From: Chris Bembridge <Chris.Bembridge@kirklees.gov.uk>
Sent: 09 April 2025 15:49
To: Danielle Cooper <Danielle.Cooper@kirklees.gov.uk>
Cc: Highways DevelopmentControl <Highways.DevelopmentControl@kirklees.gov.uk>
Subject: FW: 24/93594 Hollinghurst Farm, Honley

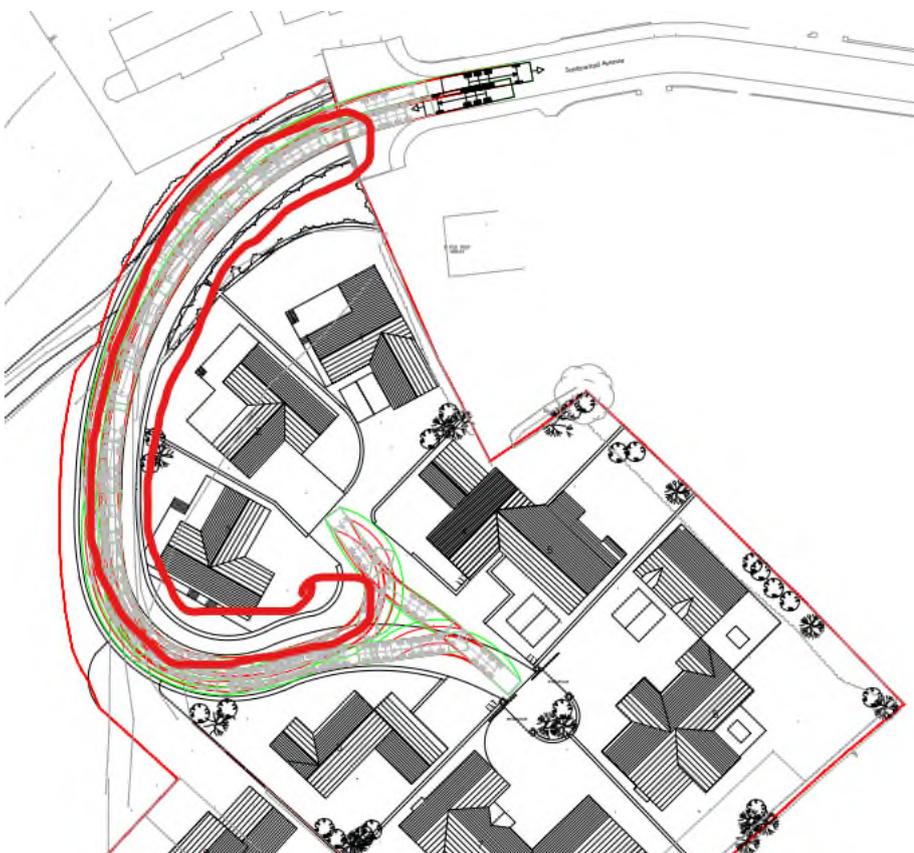
There are no visibility splays indicated. Junction and Forward Visibility Splays and dimensions must be in accordance with the Kirklees Design Guide (Table 1) and dedicated to Kirklees if they fall out of the existing highway boundary. Please provide the forward visibility splay around the bend.

A minimum carriageway width of 5.5m will be required.

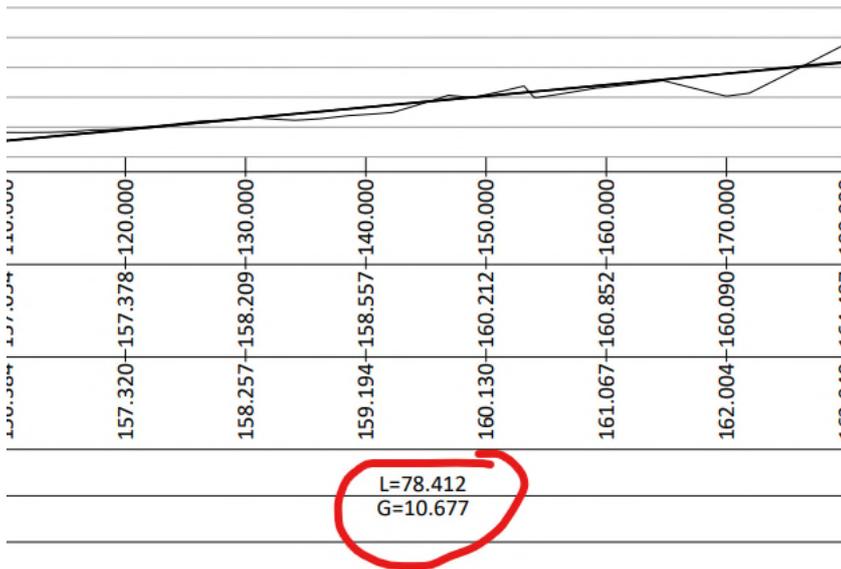
The Long Section indicates a gradient in excess of 10% which is too steep and above our criteria of a maximum of an 8% gradient and therefore this will need to be amended.

Given the vertical alignment is going to be steeper than the maximum 5% footways will be required on both sides of the carriageway.

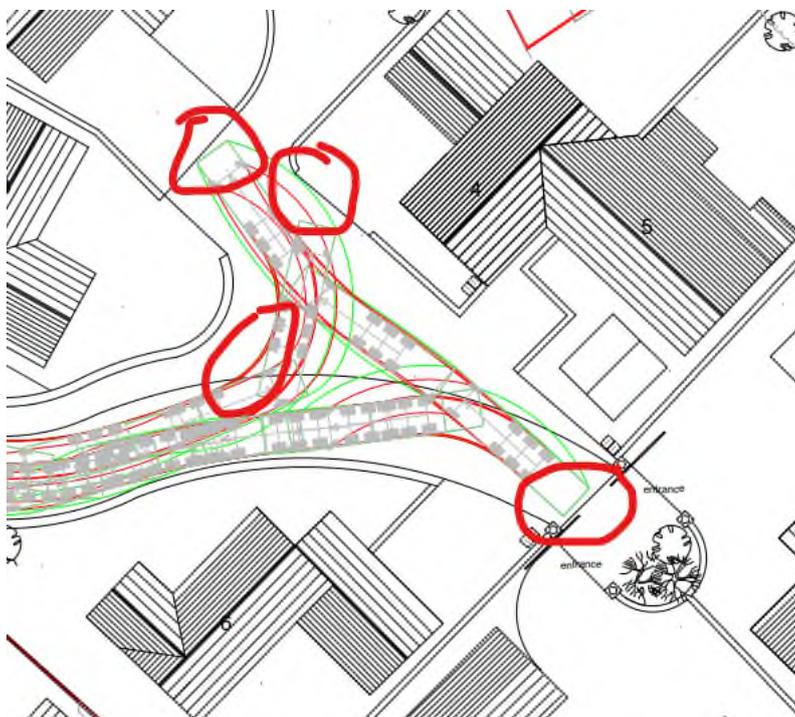
Kirklees require a swept path drawing does not indicate how a refuge vehicle can pass an on-coming car and therefore this will needed to be widened around the bend to enable this manoeuvre. The turning manoeuvre at the end is also too tight and we will expect a minimum 0.5m clearance within the limits of the highway.
